Access Compliance Report

Public Rights-of-Way

(Curb Ramps)

Intersection ID: 30169	Main Street: BUTTONBUSH_CT	Cross Street: SLATER_RIDGE_DR	Location: SW
ADA ID: E11692E2992C	Ramp Type: PerpDiag	Initial Pass/Fail: Fail	Overall Compliance: No
Severity Score: 21.25			
Codes/Mitigation Info/Possible Solution		Field Measurements/Component Compliance

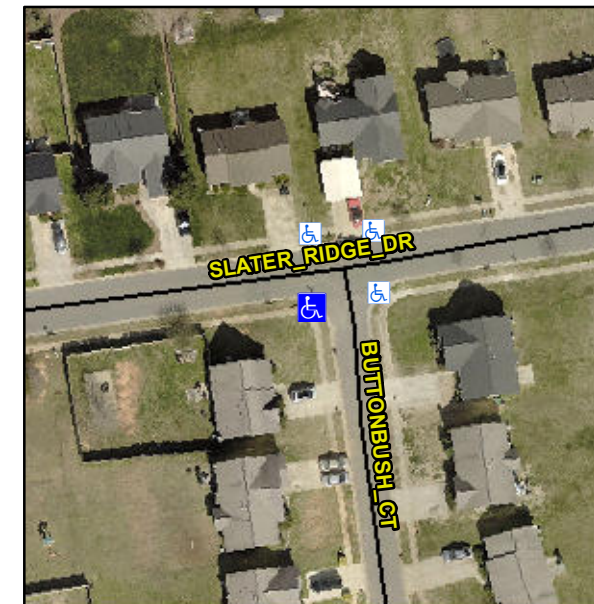
R304.5.1, R304.5.3

Compliance	Description	Data	Compliance	Description	Data
N/A	Ramp Length (in)	47.5	Yes	Ramp Slope (%)	6.5
No	Ramp Width (in)	43.0	No	Ramp XSlope (%)	5.1
N/A	Flare Type LT	N/A	N/A	Flare Type RT	N/A
N/A	Flare Slope LT (%)	N/A	N/A	Flare Slope RT (%)	N/A
N/A	Flare Traversable LT?	N/A	N/A	Flare Traversable RT?	N/A
N/A	Landing Length (in)	N/A	N/A	DWS Provided?	N/A
N/A	Landing Width (in)	N/A	N/A	DWS Contrast?	N/A
N/A	Landing Slope (%)	N/A	N/A	DWS Length (in)	N/A
N/A	Landing X Slope (%)	N/A	N/A	DWS Full Width?	N/A
N/A	Landing Curb? (Y/N)	N/A	N/A	DWS Offset (in)	N/A
N/A	Shared Landing?	N/A			
N/A	Gutter Ponding?	N/A	N/A	Gutter Slope (%)	N/A
N/A	Gutter Lip Ht (in)	1.0	N/A	Gutter X Slope (%)	N/A
N/A	Painted X Walk1?	No	N/A	Painted X Walk2?	No
	X Walk 1 Direction	To E		X Walk 2 Direction	To N
N/A	X Walk 1 Width (in)	N/A	N/A	X Walk 2 Width (in)	N/A
	X Walk 1 Slope (%)	1.6		X Walk 2 Slope (%)	0.5
	X Walk 1 X Slope (%)	1.1		X Walk 2 X Slope (%)	1.5

Remove & Replace Curb Ramp With Two New Directional Ramps or Equivalent.
